TO:  MAIN OFFICE  REGIONAL OFFICES <b>SUPERSEDED BY EI 75-070</b> <b>EFFECTIVE 10/20/1975</b>	 <b>ENGINEERING INSTRUCTION</b> NEW YORK STATE DEPARTMENT OF TRANSPORTATION
	SUBJECT: BDD 73-60, 73-62 and 73-63.  Subject Code: 7.35-2-60, 62, 63
Distribution: <input checked="" type="checkbox"/> Main Office <input checked="" type="checkbox"/> Regions <input type="checkbox"/> Special  APPROVED:  Deputy Chief Engineer (Structures)	Code: EI 73-61 Date: Aug. 22, 1973 Supersedes: BDD 72-60, 72-62 and 72-63

Attached are copies of the subject sheets for distribution to your personnel. The principal changes on these sheets are as follows:

DETAIL OF HEADED CONCRETE

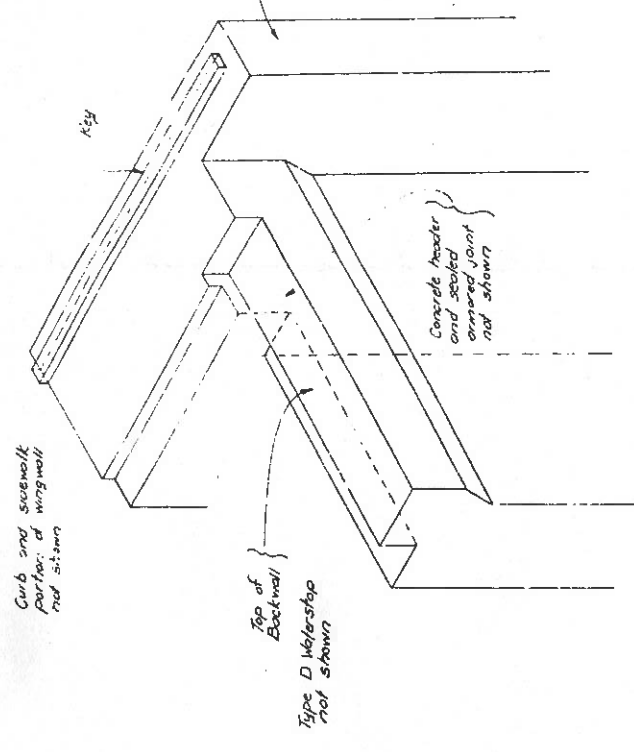
1. The 4" x 7" x 3/8" clip angles are spaced at 24" ctrs. instead of 12" ctrs.
2. The size of the concrete anchor was changed from 5/8"Ø - 3½" lg. to 3/4"Ø - 3-7/8" lg.
3. The details for the cutting and bending of the seal was added. Also, the detail for the concrete anchor was added.
